From: Biazar, Shahab
Sent: Friday, November 08, 2013 8:48 AM
To: 'Trula Howe'
Subject: RE: Confirm

SANTA FE FEDERAL CREDIT UNION
GRADING AND DRAINAGE PLAN
ALBUQUERQUE, NEW MEXICO

SHEET NUMBER
C.1

Re: Santa Fe Federal Credit Union, 7101 Jefferson Street NE, Grading and Drainage Plan, Engineer's Stamp dated 06-04-2013 (D-17/D017)

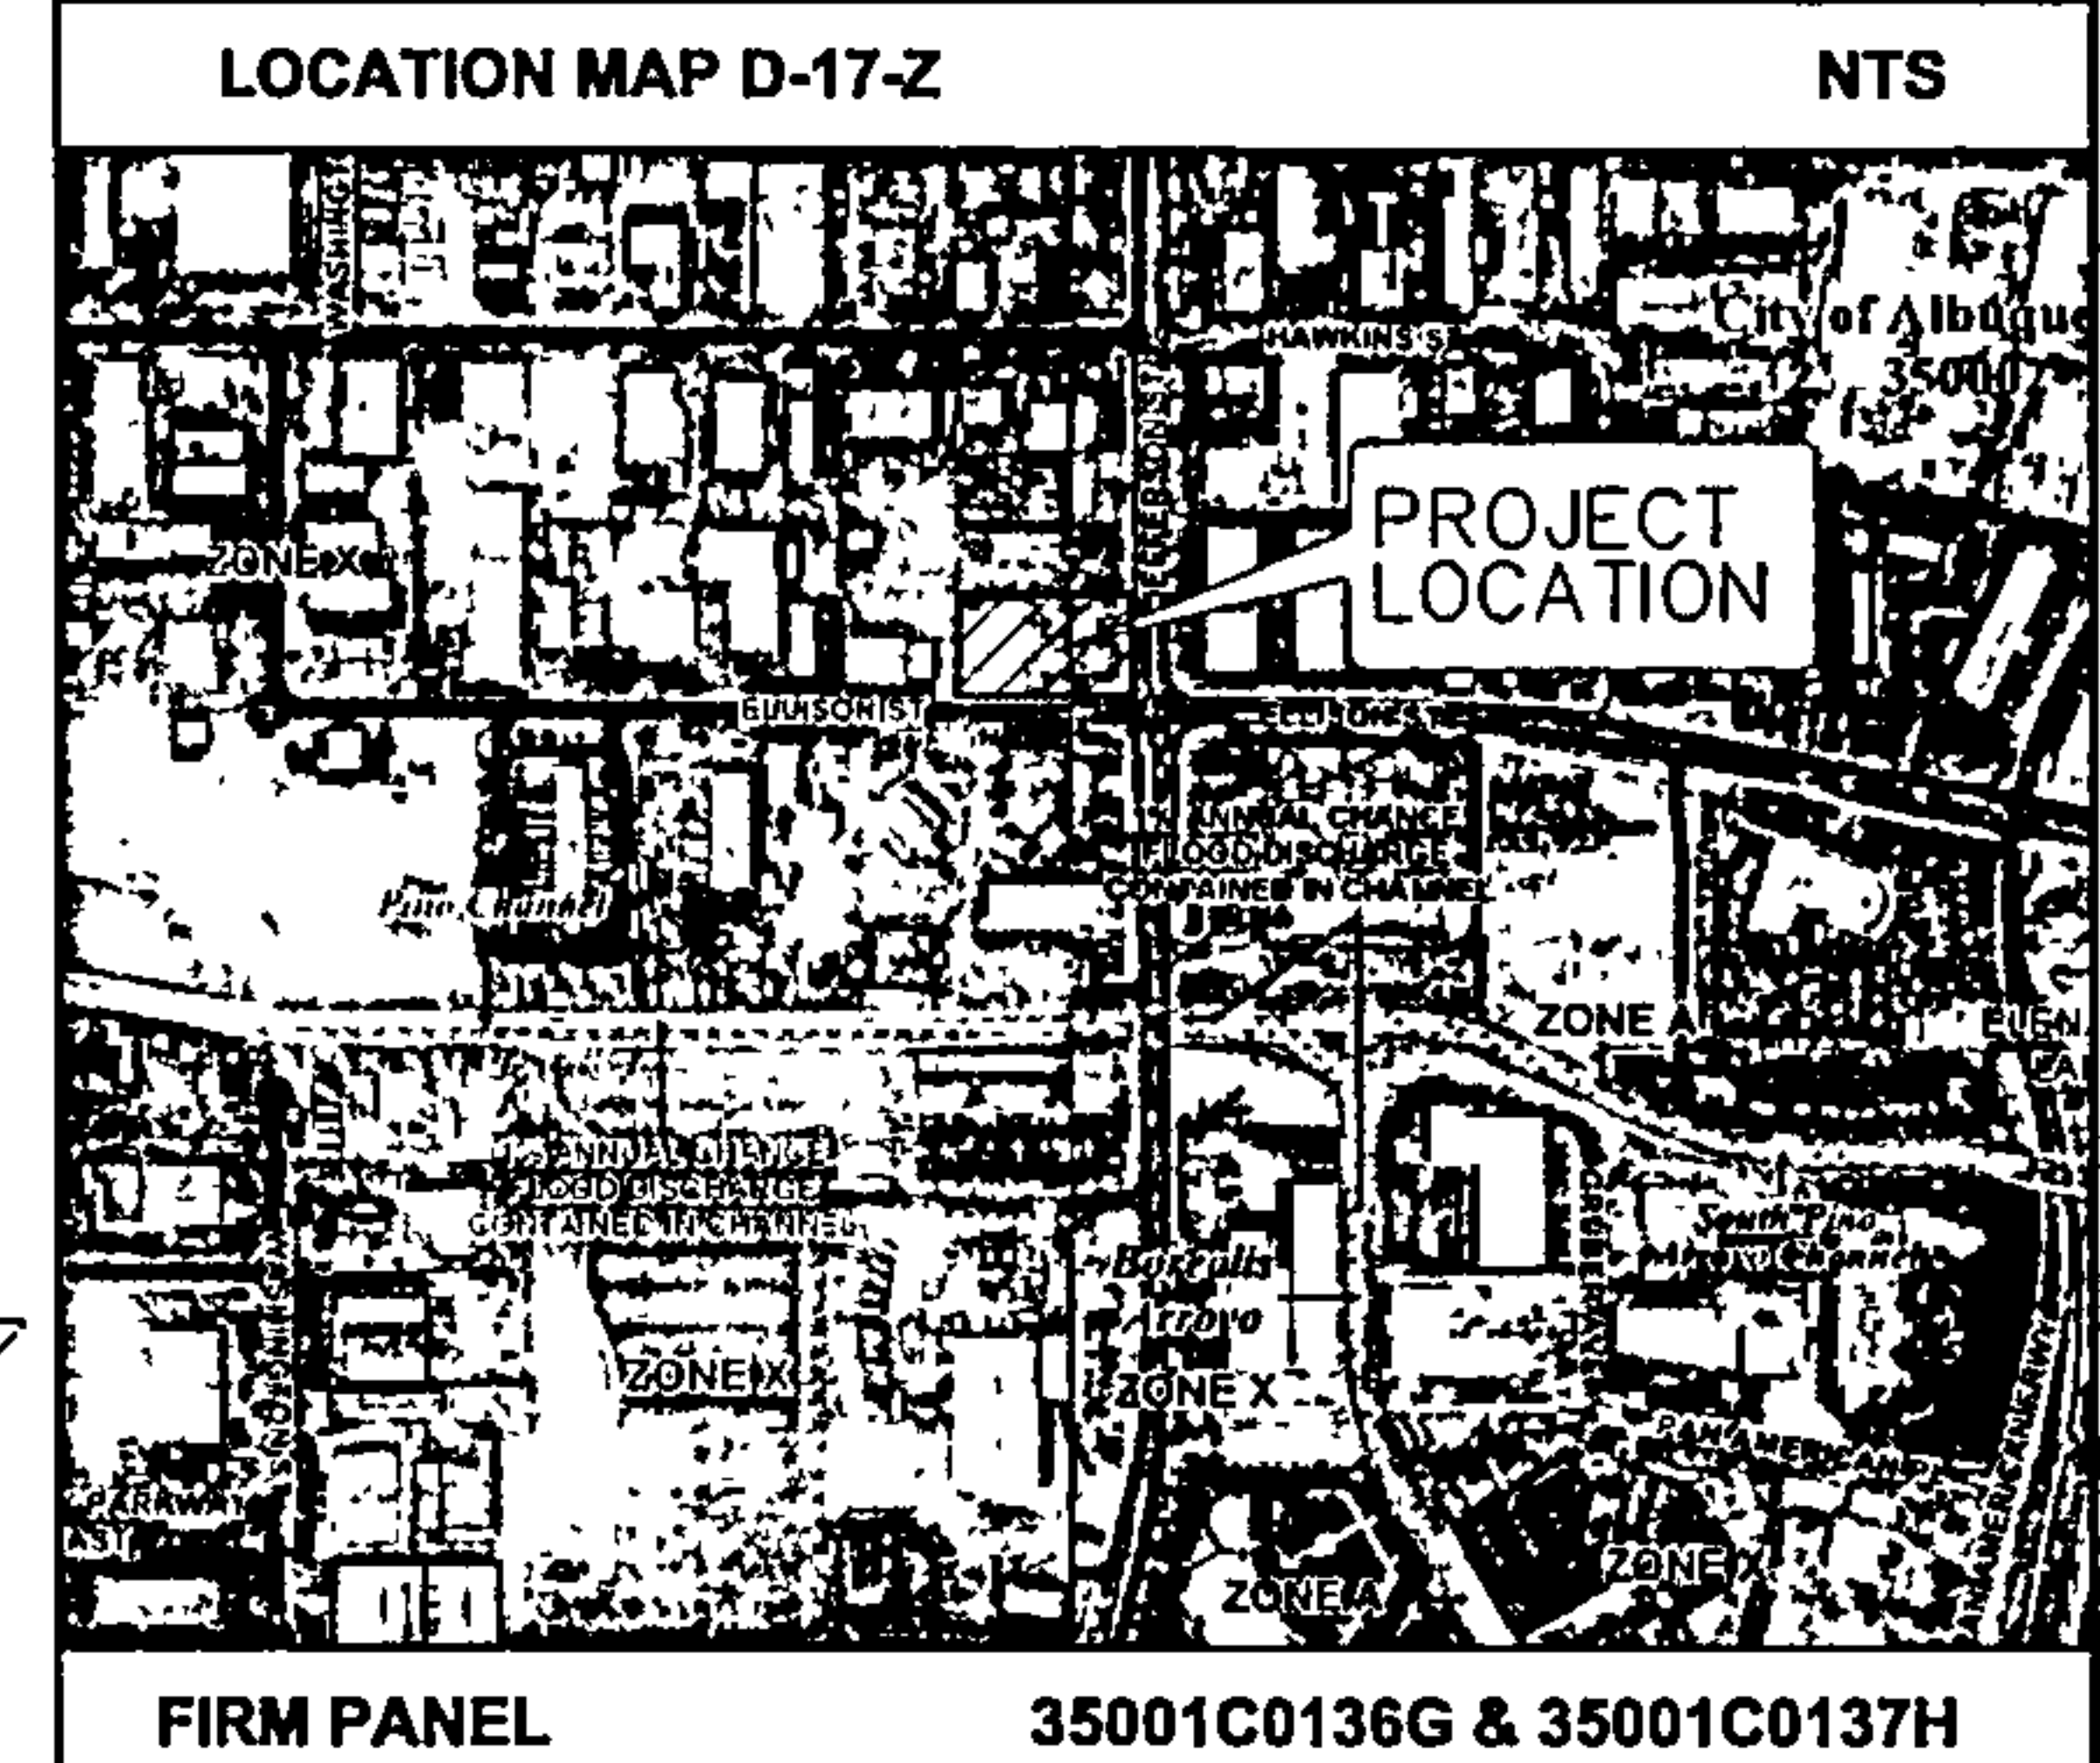
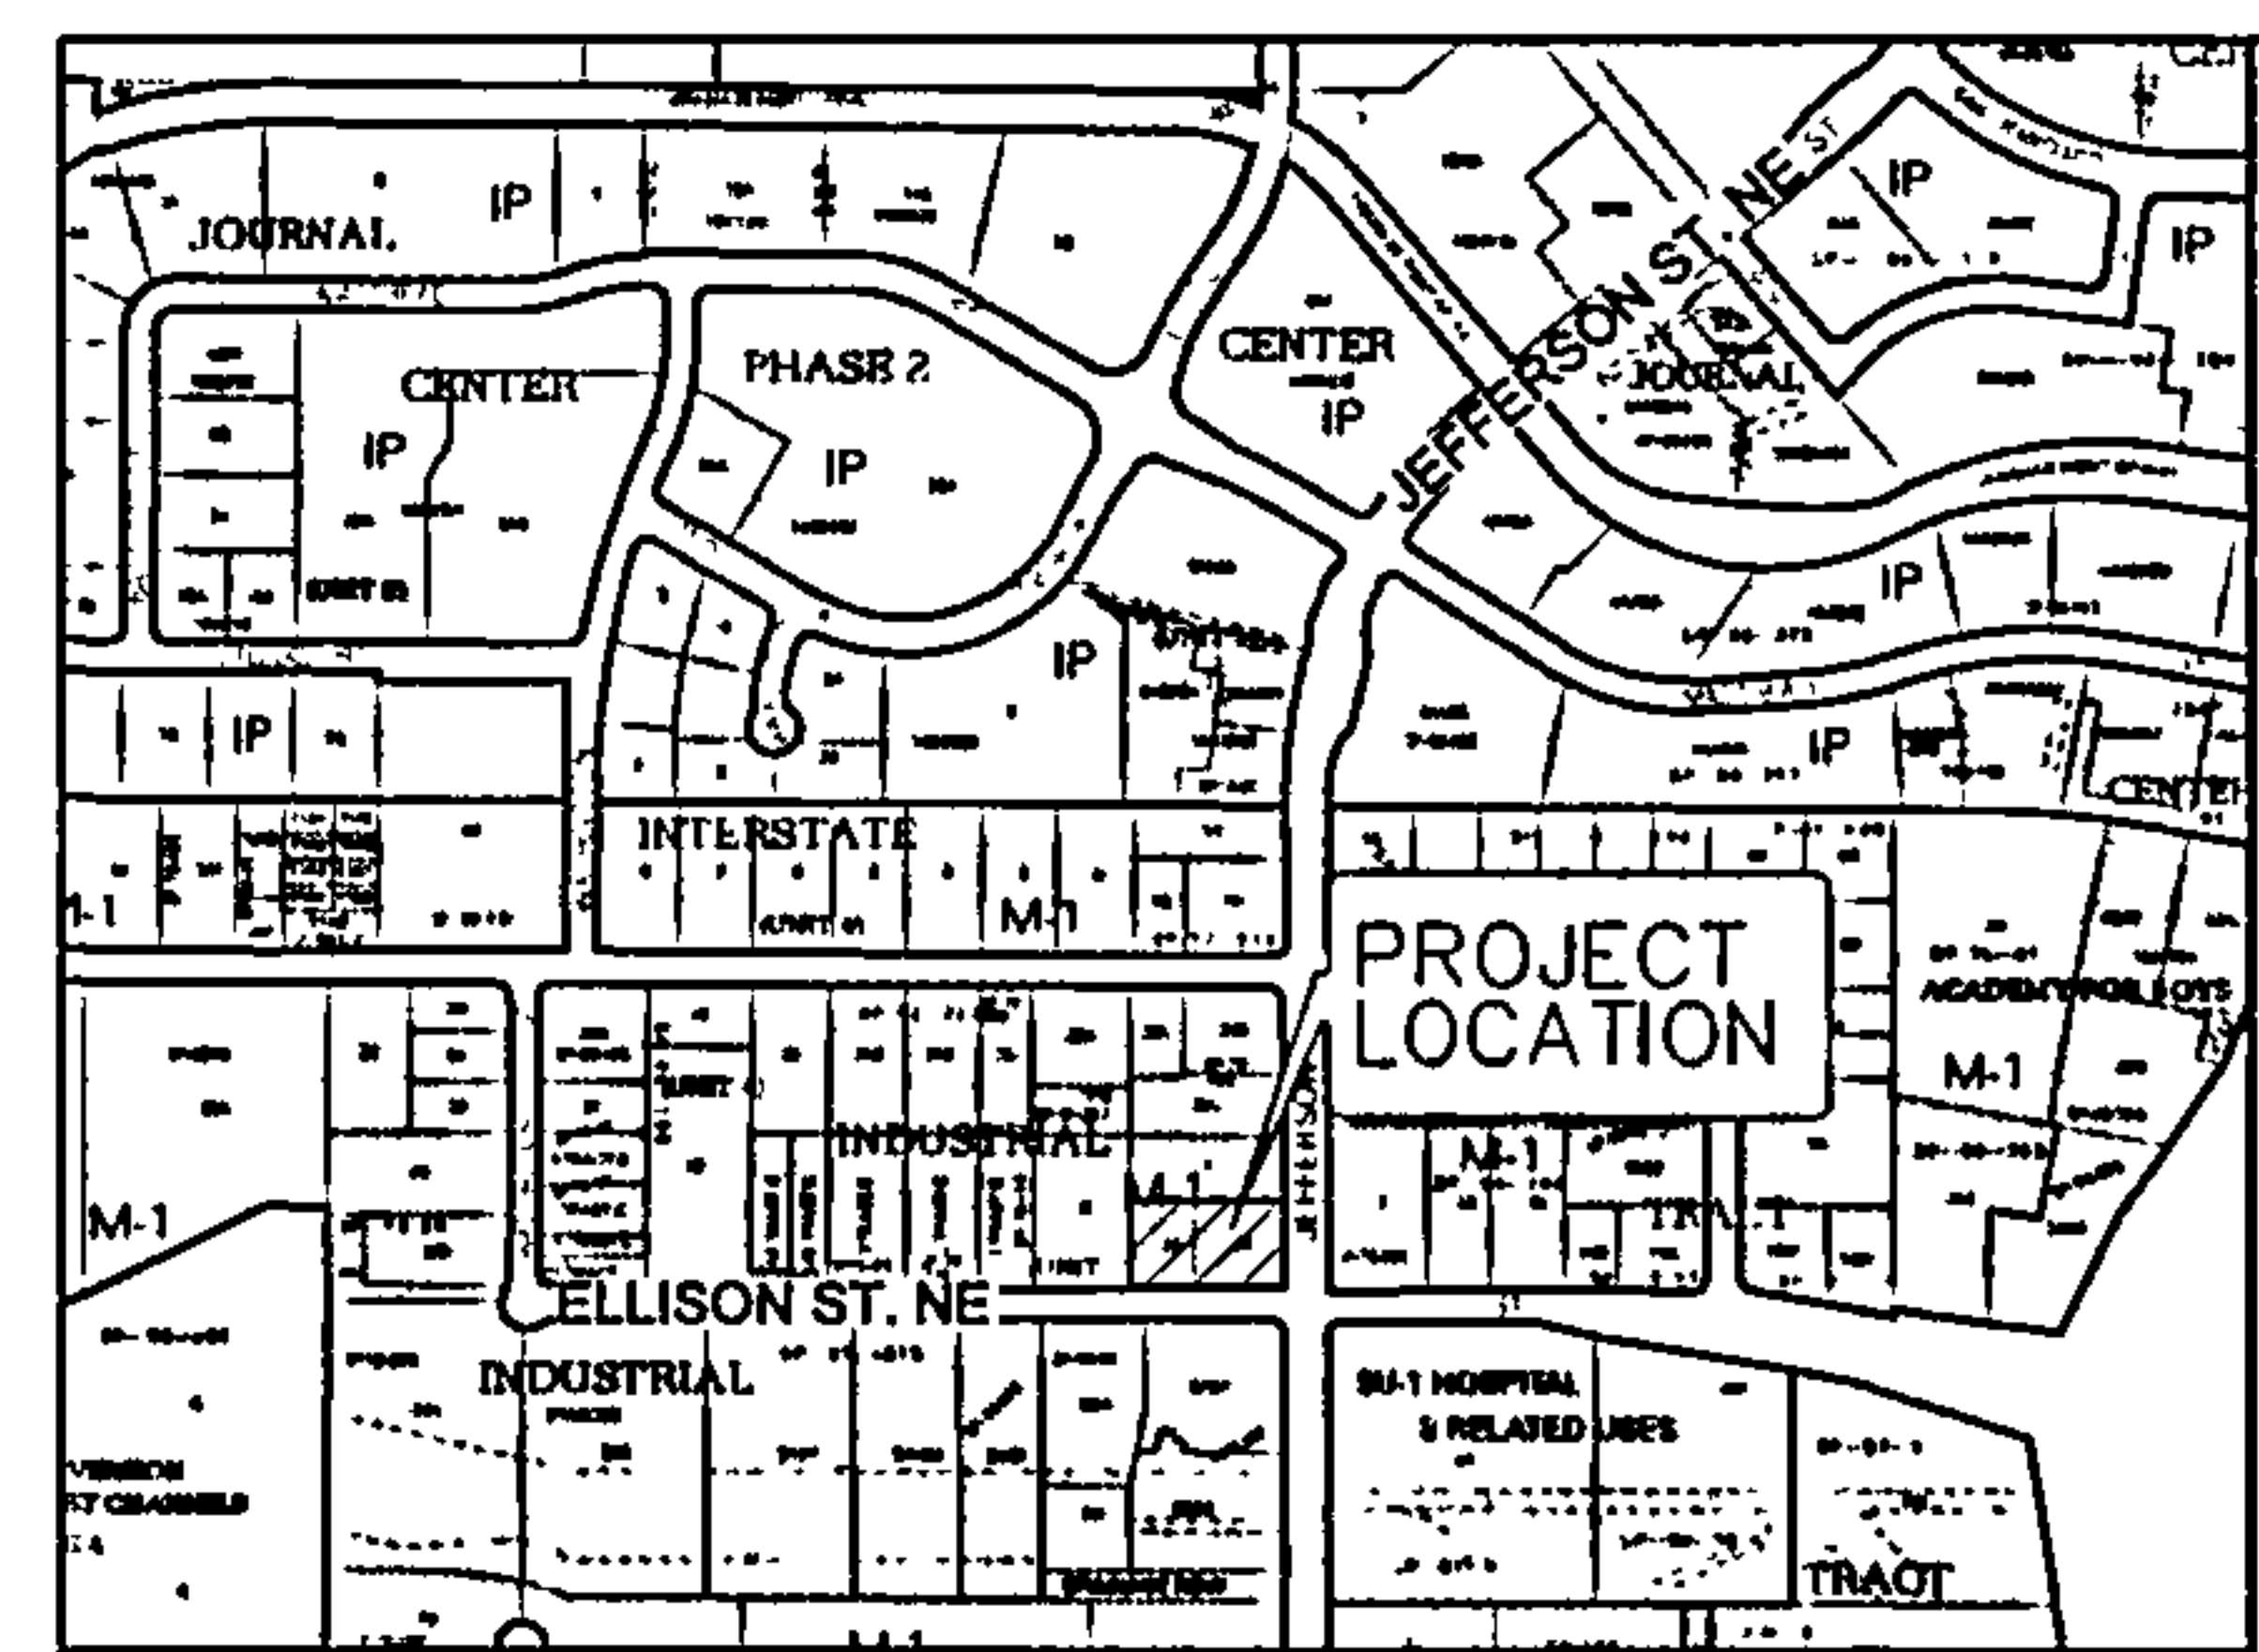
- Please quantify the offsite flows from the parking lot to the north of your project and include these flows in the drainage calculations for the existing sidewalk culvert; if over capacity address how these flows will be accommodated.
- Add a note to extend the culvert and culvert plate two feet back from the property line and to tack weld the bolts to the steel plate.
- Clarify if the existing swale is completely asphalt lined. Satellite imagery shows a significant amount of sediment in this channel.
- If the sidewalk culvert is altered please provide both an invert elevation and flowline elevations within Ellison Street.
